From: Wolfenbarger, Jeanne
Sent: Friday, June 19, 2015 4:08 PM
To: 'David Soule'
Subject: F22-D002 (Sandia Area Federal Credit Union/Starbucks)

**RE: Grading and Drainage Plan
F22-D002
11301 Montgomery**

**RE: Sandia Area Credit Union and Starbucks, 11301 Montgomery Boulevard
Grading and Drainage Plan
Engineer's Stamp Date 6-01-2015 (File: F22-D002)**

ENGINEER'S SEAL 6/18/15 DAVID SOULE P.E. #14522	Saftca & Starbuc	GRADING AND DRAINAGE PLAN Rio Grande Engineering 1808 CENTRAL AVENUE SUITE 201 ALBUQUERQUE, NM 87108 (505) 872-0888	DRAWN BY DEM
			DATE 8-14
			SHEET # 1 of 2
			JOB # XXXXX

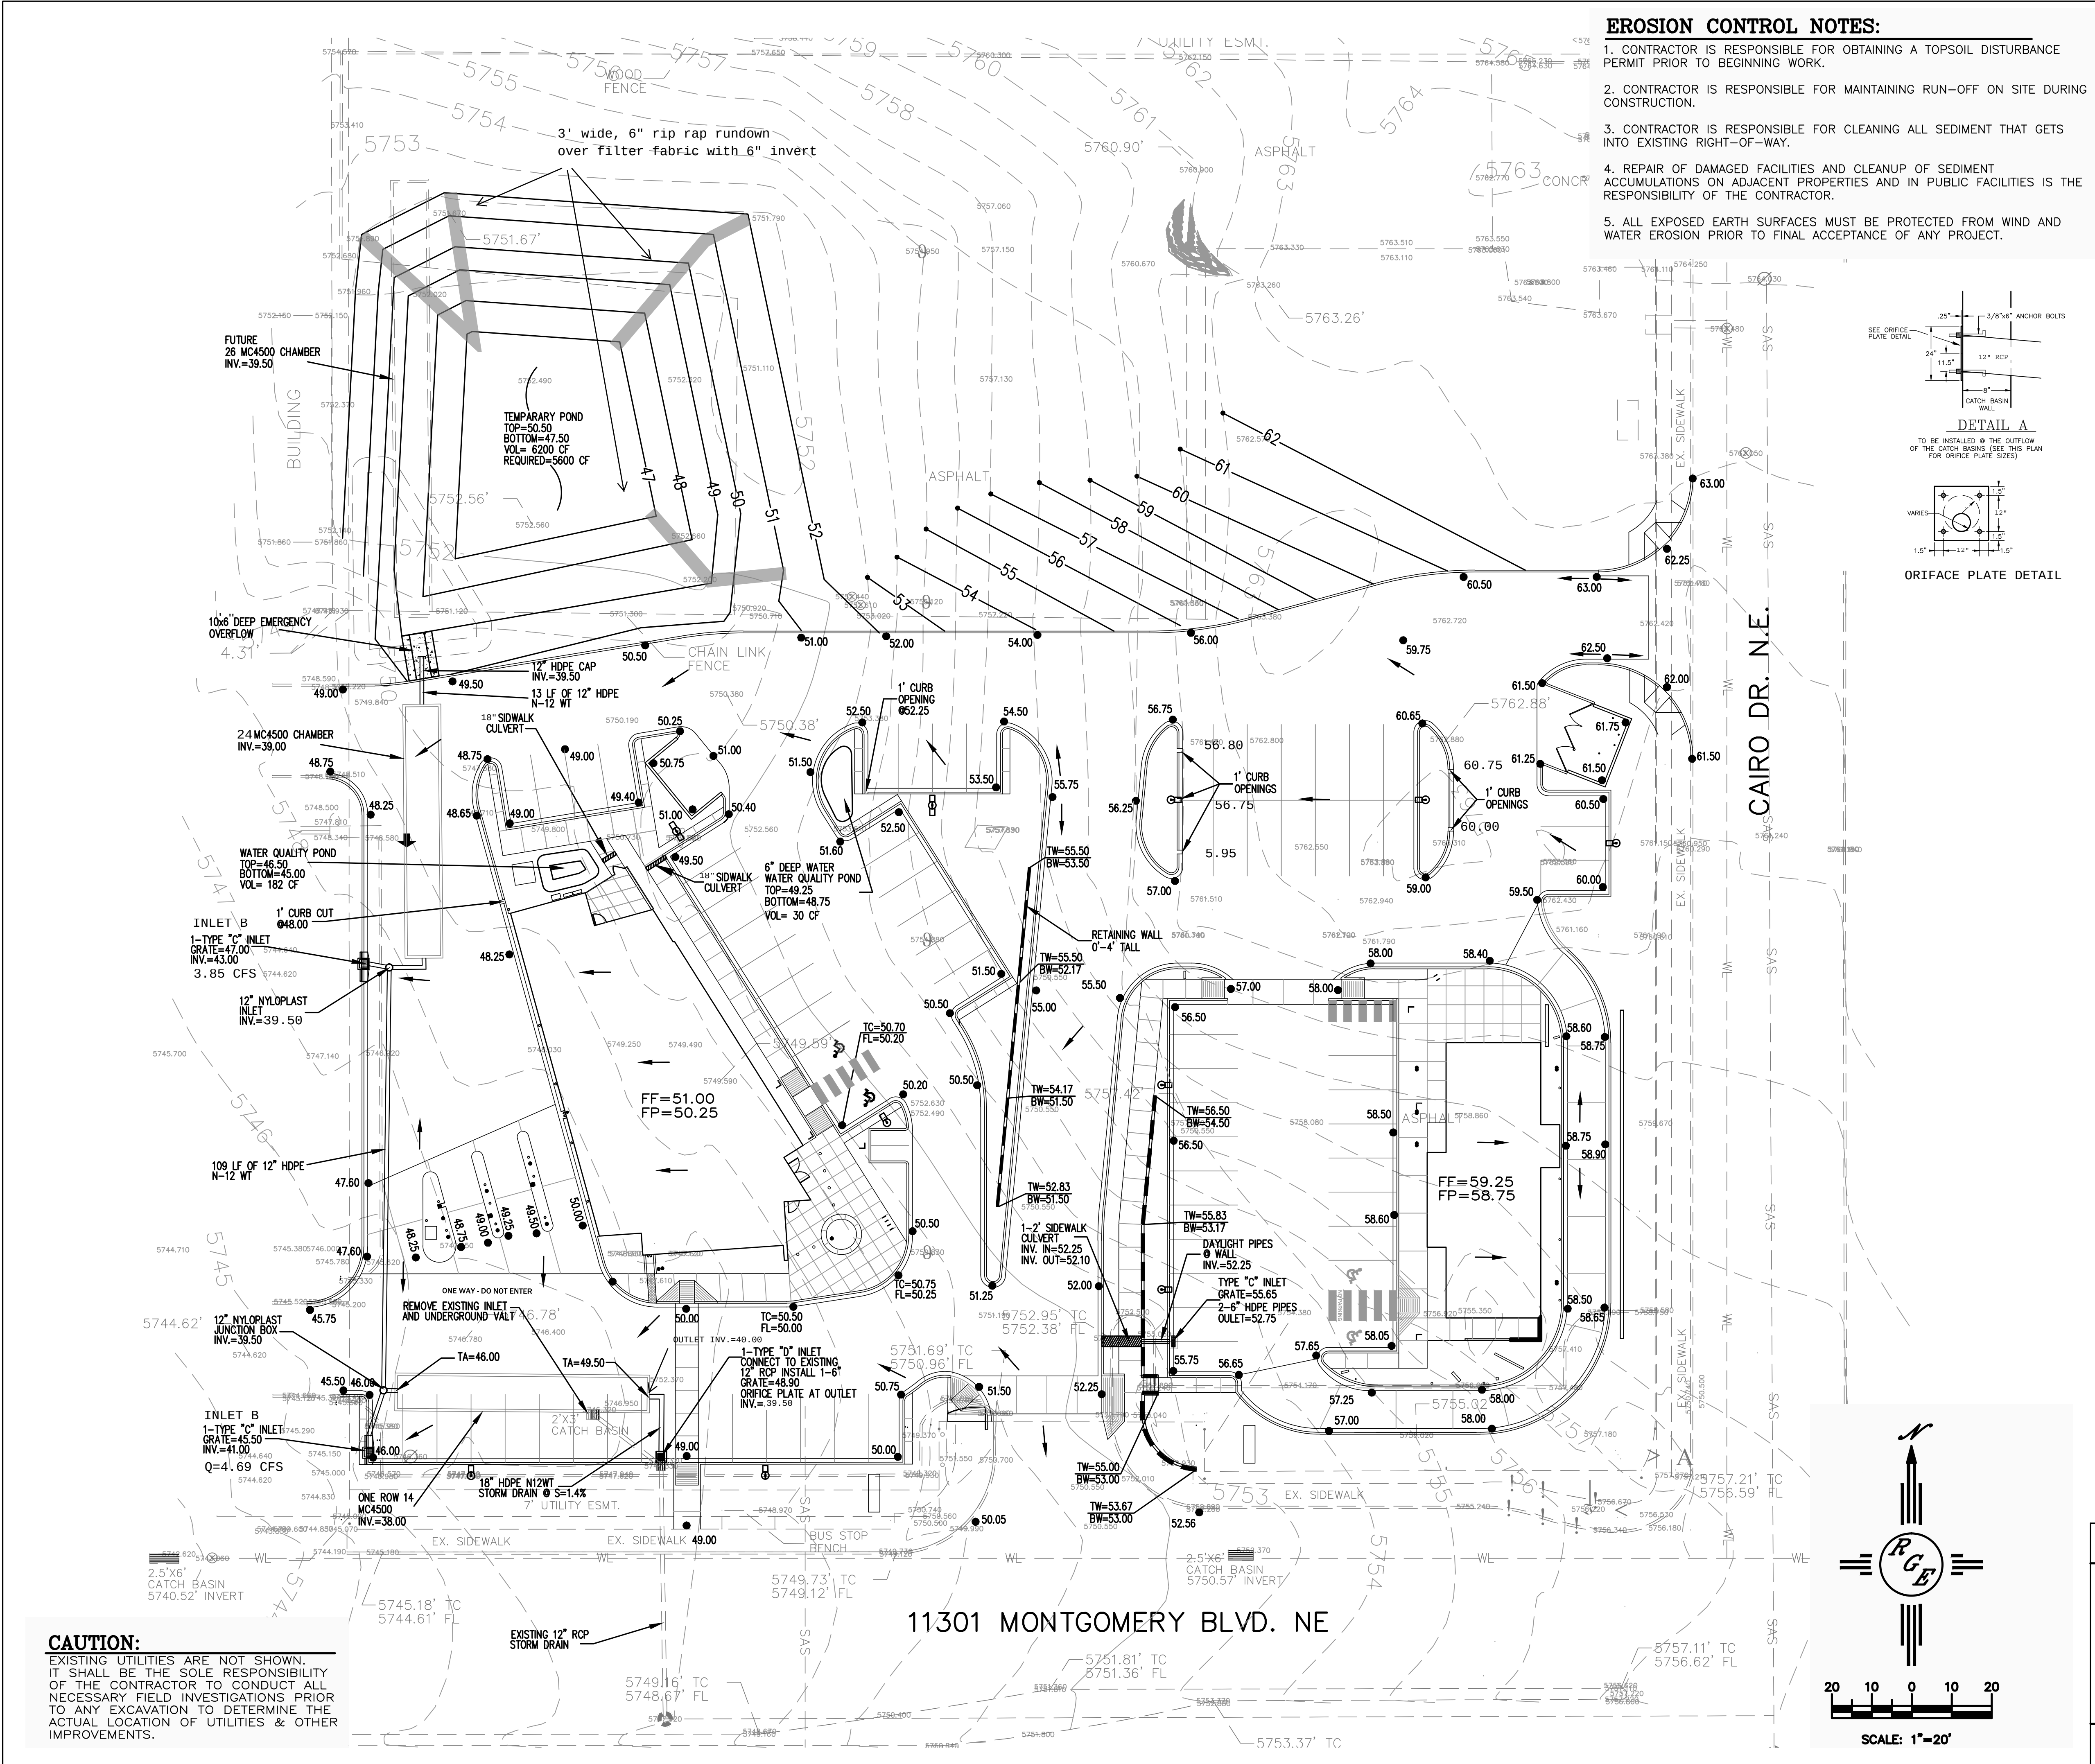
I have reviewed the latest drainage submittal and still need to have the following comments addressed prior to approval:

1. If the temporary pond is now sized to handle the 100-year 10-day storm runoff, label the WSEL Elevation within the pond on the plan view.
2. On the actual grading and drainage plan view, label the first flush volume for each run of the storm chambers that corresponds with drainage write-up. Also, label the total volume provided by the storm chambers on the plan view that corresponds with the drainage write-up. (Provide this information directly under the label showing number of storm chambers for each run of the storm chambers.)

3. Label all pipe sizes on the plan. There are some short pipe runs especially from the that are missing pipe size call-outs.
4. Provide detail for the 10-foot by 6" emergency overflow from the temporary pond. List the elevations. (It would make sense that the above invert elevation within the pond is above the WSEL Elevation from the upstream pond when labeling it.)

5. On the water quality pond in the middle of the site, the top elevation of 49.25 is far lower than the adjacent curb cut elevation opening of 52.25 and other adjacent curb elevations. Revise as necessary.

6. On the water quality pond on the west side of the site, there are top of pond elevations of 46.5 shown where the adjacent sidewalk would be approximately 4 feet higher based on the adjacent curb flowline elevations, and the adjacent building is also approximately 4 feet higher. Revise as necessary.

7. There are new 18-inch sidewalk culverts called out on the plan near the water quality pond to the west that have no elevation information listed. Also, how does water drain from the other 18-inch sidewalk culvert to this one? Provide a couple more spot elevations for information.

8. When you mention the cross-lot drainage easements in the write-up, there is only one parcel. (?)

- 1) Show first flush calculation within the report. Show roof drain locations, and explain how first flush is being managed especially with regard to impervious facilities on the east side of the site. It appears as though an additional first flush pond may be needed to handle first flush from the building on the southeast corner of the site with added curb cuts to allow drainage into the pond from the drive-thru area. Label all first flush ponds as "first flush" along with volume information.

- 2) Show flow arrows and lot lines on the grading and drainage plan.
- 3) What are the curb cuts in the medians to the north of the Starbucks for? If a first flush pond was intended here, label it, and provide elevation and volume information. Provide curb flowline elevations at all curb openings.

- 4) Show existing curb elevations on Cairo at the access point, and show existing elevations along west property line to show how these existing elevations relate to new elevations. On the north side of the site, provide elevations for the existing building that abuts the property line, and ensure that the new contours tie into the correct existing contours.

- 5) Discuss what the temporary pond is for. What is the sizing of it based on since the 100-year 6-hour volume is much higher for Basin A? Discuss what the plans are for Basin A since an impervious area of 0.988 acres was given in the computations.

Also provide riprap within the proposed swale to the bottom of the pond from the east to prevent erosion.

- 6) Provide a larger basin map. An 11x17 would be easier to read along with upsizing of the text for the labeling of the basins.
- 7) Label grate elevation for the new Type "D" inlet. Provide a detail showing all elevation information for inlet including information for orifice. Show how this inlet ties into the storm chambers with pipe invert and size information.

- 8) Label size of Nyloplat junction boxes and the pipes that tie into the storm chambers. Between the high invert elevation of 48.00 for discharge from the site and the high invert elevations of the connecting nyloplat junction boxes, how does the entire system manage to drain, given that the top of the storm chambers are set at elevation 42.50??

- 9) For the AHYMO Run, show what the pond routing information is based on. Provide computations based on orifice for which the elevations given match what is on the plan.

- 10) Discuss what the downstream capacity of 4.7 cfs for the existing outlet is based on. The proposed discharge flow should match downstream capacity.

- 11) On the proposed layout for the storm chambers with the report, label the number of chambers used and the volume of each chamber. Then provide the overall volume for the chamber on this sheet and on the plan view. Provide a cross-sectional view of the storm chamber similar to what is shown on the report showing a detail of the stone and fabric surrounding it if it is just for one row. (It should be similar to the cross-section provided in the report for the multiple chambers.)

- 12) In the report, explain location of infrastructure for which capacities calculations were provided. Where is there a channel? What are the "Volume Computations" based on? Also include capacity calculations for the sidewalk culvert and for the Type "D" inlet within the "Inlet Capacity Calculations". On the plan view for the grading and drainage plan, label the discharge flow from the site, and label the flow captured at each of the inlets.

- 13) North of the credit union building, there is a curb cut elevation at an elevation of 49.40 which should be lowered if the intent is to drain to the "water quality pond". Also, the nearby "water quality" pond is labeled at an elevation of 46.50 for the top elevation. Correct discrepancy. Also, provide additional elevation information for the corners of the trash receptacle area.

- 14) If the proposed elevations shown are at flowline, provide general note to this effect.
- 15) Show AHYMO Run in 10-minute increments until about 90% of the pond has drained to demonstrate a more clear relationship between inflow and outflow. How does the pond have a constant outflow of 1.68 cfs for a time period of more than 8 days when it peaks at 1.75 hours??

16) Provide a small valley gutter from the sidewalk culvert from Starbucks across the accessway to prevent flow from discharging out the accessway.

1. We have added the first flush calculation to the hydraulic calculations in appendix A. We have shown roof and flow arrows. The entire flow passes thru the infiltrators and the outlet elevation provides the volume, as shown on the elevation-volume spread sheet located in appendix b.

2. We have added flow arrows.
3. We have not added elevations at the islands; we are not depressing the islands but allowing the water to pass thru and top the curb on the low side.

4. We have added the spot elevations at the street and adjacent building.
5. The plan has changed due to uncertainty with what the future lot will look like. Due to the slope and nature of our drainage solution, we do not want bare dirt areas to contribute to our infiltrator systems; therefore, we have modified the plan to retain the entire 100-year, 10-day volume generated within that basin. We have shown that 30 infiltrators with invert at 39.5 will be a reasonable solution when it develops; we have added stub for that to occur. We have added rip rap at the flow concentrations.

6. We have included a 11x17 basin map.
7. We have added the elevation of the inlet and added an orifice plate detail.
8. We have labeled the junction boxes and corrected the typo.

9. Appendix B and C contain the volume calculations for each tank section as well as a summary based upon the elevations. The pond calculation spreadsheet is a stage-storage chart that was used for the pond routing volumes in the AHYMO.

10. The discharge rate of 4.7 was the rate designated for the site on the initial development.
11. We have labeled the number of chambers and included a modification to the detail for a single row.

12. We have labeled the inlets and referenced the location of the structures on the calculation.
The type D inlet is provided only to provide adequate box to construct orifice control most flow will not enter that inlet, inlet D is designed for all flow so the capacity of the type D inlet is not relevant
13. The dumpster was revised, and the spot elevations corrected
14. Note #1 on right hand side of sheet notes all elevations are flow lines
15. We have corrected the AHYMO for 15 minute increments and corrected the input so there is not the phantom flow
16. As discussed in the meeting the asphalt warps at that area and gutter not needed
